Access Compliance Report

Public Rights-of-Way

(Curb Ramps)

Intersection ID: 46605	Main Street: E_WOODLAWN_RD	Cross Street: PARK_RD_SHOPPING_CENTER_DR	Location: NW
ADA ID: 73E89328A850	Ramp Type: Perp	Initial Pass/Fail: Fail	Overall Compliance: No
Severity Score: 8.75			
Codes/Mitigation Info/Possible Solution		Field Measurements/Component Compliance

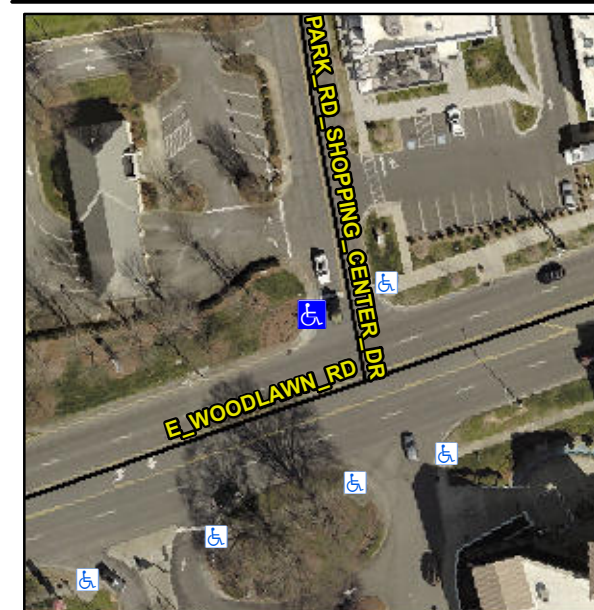
Not Found, R304.5.1

Compliance	Description	Data	Compliance	Description	Data
N/A	Ramp Length (in)	25.0	Yes	Ramp Slope (%)	6.5
No	Ramp Width (in)	47.0	Yes	Ramp XSlope (%)	1.3
N/A	Flare Type LT	N/A	N/A	Flare Type RT	N/A
N/A	Flare Slope LT (%)	N/A	N/A	Flare Slope RT (%)	N/A
N/A	Flare Traversable LT?	N/A	N/A	Flare Traversable RT?	N/A
N/A	Landing Length (in)	N/A	N/A	DWS Provided?	N/A
N/A	Landing Width (in)	N/A	N/A	DWS Contrast?	N/A
N/A	Landing Slope (%)	N/A	N/A	DWS Length (in)	N/A
N/A	Landing X Slope (%)	N/A	N/A	DWS Full Width?	N/A
N/A	Landing Curb? (Y/N)	N/A	N/A	DWS Offset (in)	N/A
N/A	Shared Landing?	N/A			
N/A	Gutter Ponding?	N/A	N/A	Gutter Slope (%)	N/A
N/A	Gutter Lip Ht (in)	N/A	N/A	Gutter X Slope (%)	N/A
N/A	Painted X Walk1?	No	N/A	Painted X Walk2?	N/A
	X Walk 1 Direction	To E		X Walk 2 Direction	N/A
N/A	X Walk 1 Width (in)	N/A	N/A	X Walk 2 Width (in)	N/A
	X Walk 1 Slope (%)	1.8		X Walk 2 Slope (%)	N/A
	X Walk 1 X Slope (%)	1.0		X Walk 2 X Slope (%)	N/A

Remove & Replace Entire Ramp.
